LUSCOMBE AIRPLANE CORPORATION  
DALLAS 1, TEXAS

~~REVISION~~ BULLETIN NUMBER 3-46

SUBJECT: Installation of Rudder Return Springs, Model 8A  
Serial Numbers 1925-3049

SUBJECT: Installation of Rudder Return Springs, Model 8A

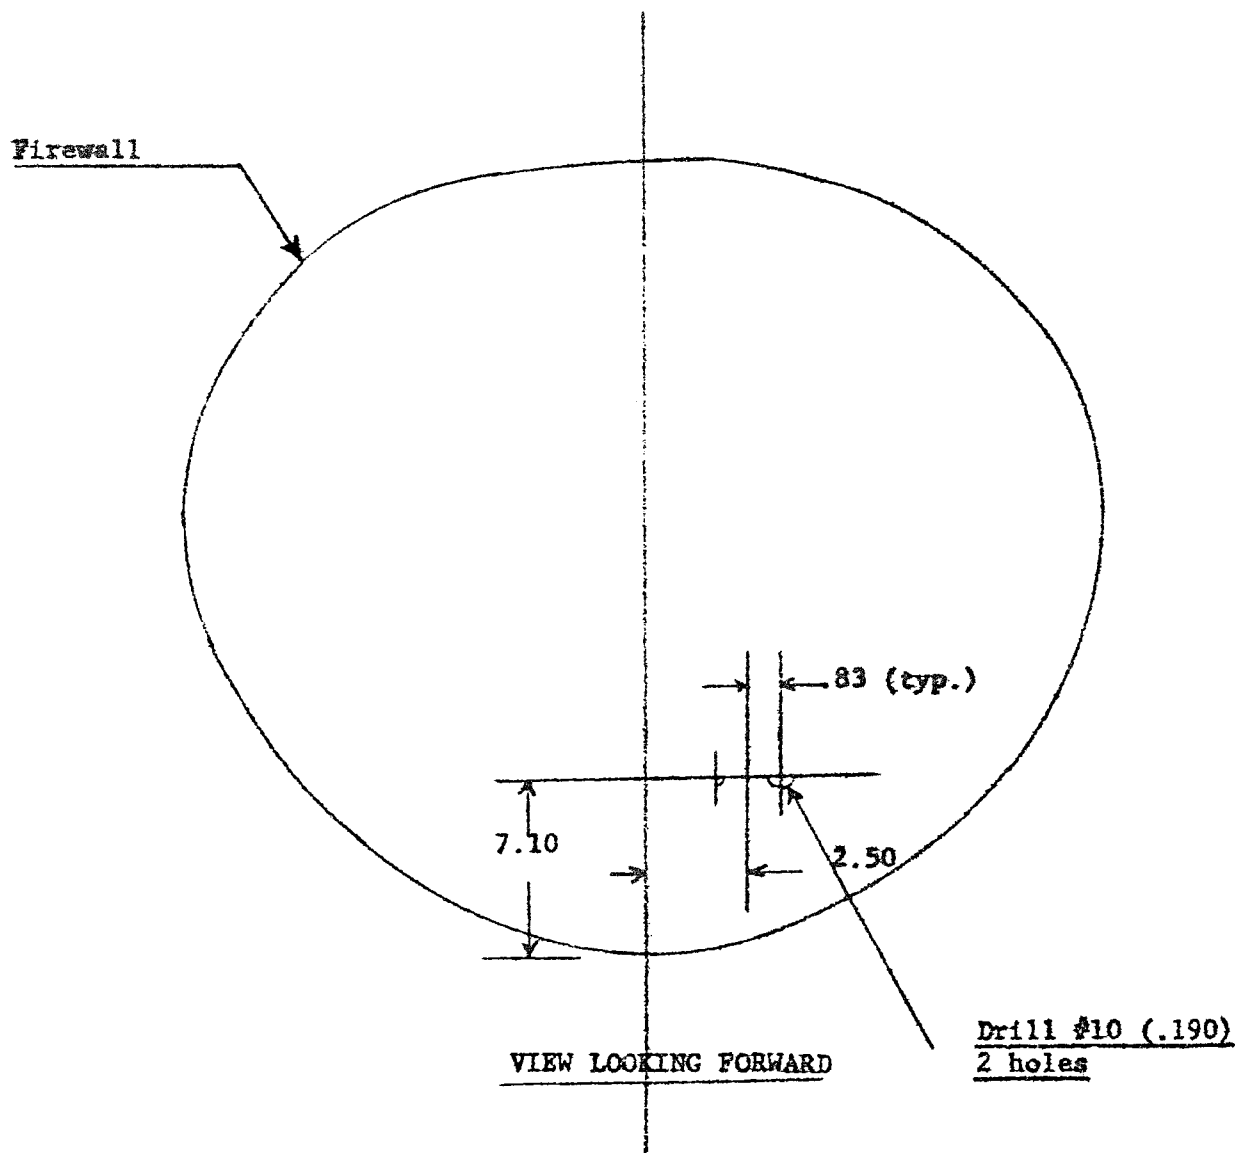
1. Drill two #10 (.190) holes in firewall, located as per sketch.
2. Drill one #30 (.1285) hole in each rudder control horn, located as per sketch.
3. Install springs between firewall and rudder control horns, using AN42-6 bolts for connection springs to firewall. The spring tension may be varied slightly by carrying the arrangement of the washers on either side of the firewall until the rudder is held perfectly neutral by the springs.

NOTE: that the left spring is installed with a 1" steel link between the spring and the firewall.

SUBJECT: Installation of Rudder Return Springs, Model 8A

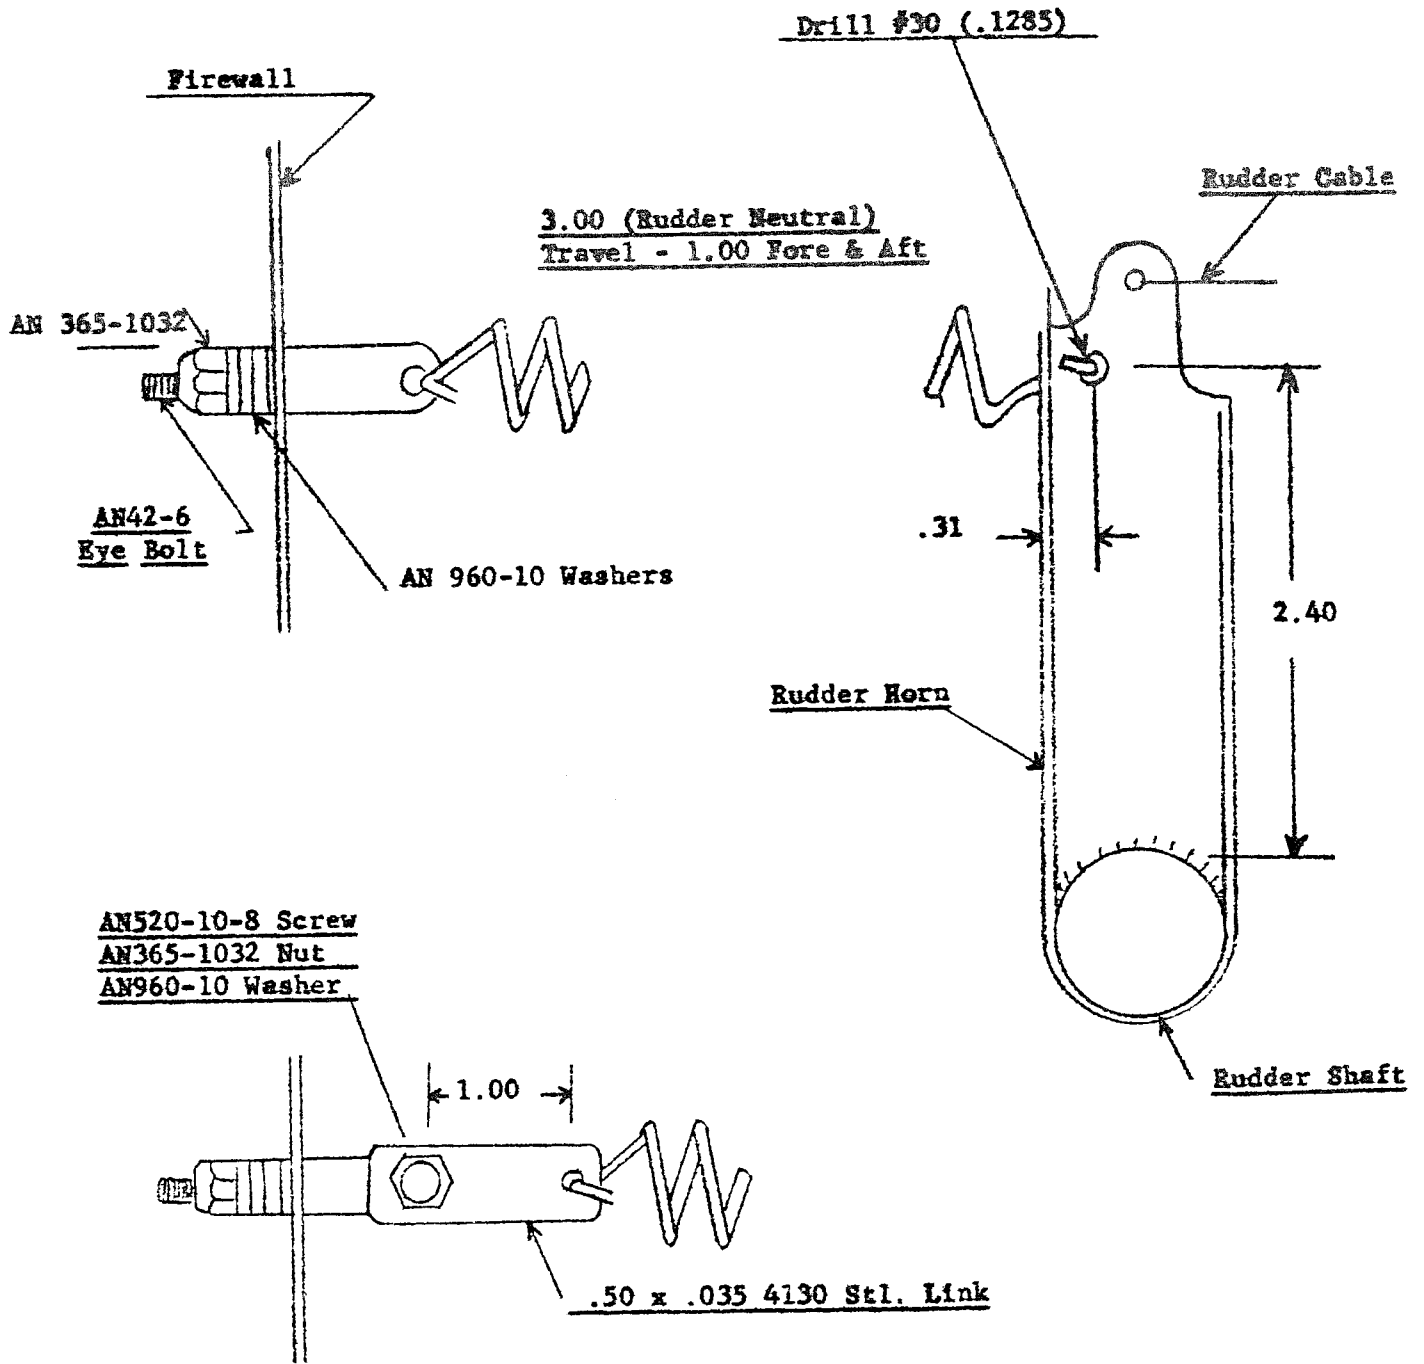
NOTE: For left spring installation  
use link as shown.
